Technical Service Bulletin: TSB140141

Exhaust Gas Recirculation (EGR) Cooler Connection Adapter Exhaust Outlet Tube

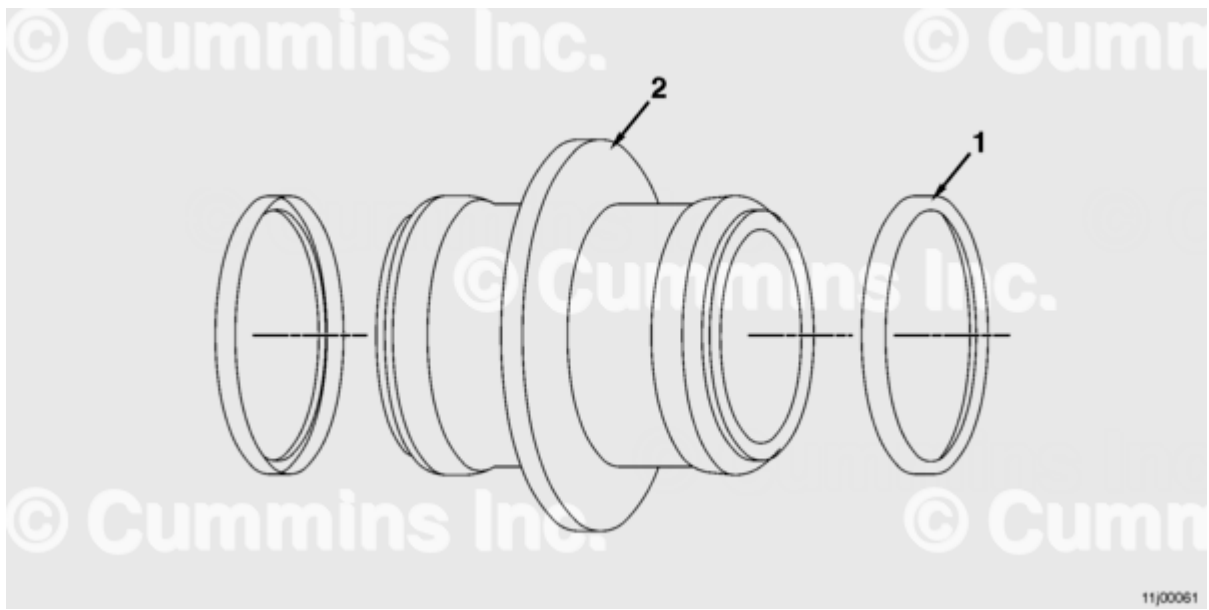
This document addresses the ISX12 CM2350 X102 and ISX15 CM2350 X 101 engines equipped with Exhaust Outlet Pipe Assembly, Cummins® Part Number 3689355. The exhaust outlet tube part numbers for this option are: Cummins® Part Numbers 3688486 and 3683940. If a leak of the joint between the exhaust outlet pipe and the exhaust manifold or a leak between the EGR cooler and exhaust outlet pipe occurs, **only** replace the exhaust outlet pipe assembly, Cummins® Part Number 3689355. Do **not** replace the exhaust manifold seals. Use the following procedures for directions on removal and installation of the adapter. Refer to Procedure 011-024 in Section 11 for the ISX12 CM2350 X102 Service Manual, Bulletin 4310646.
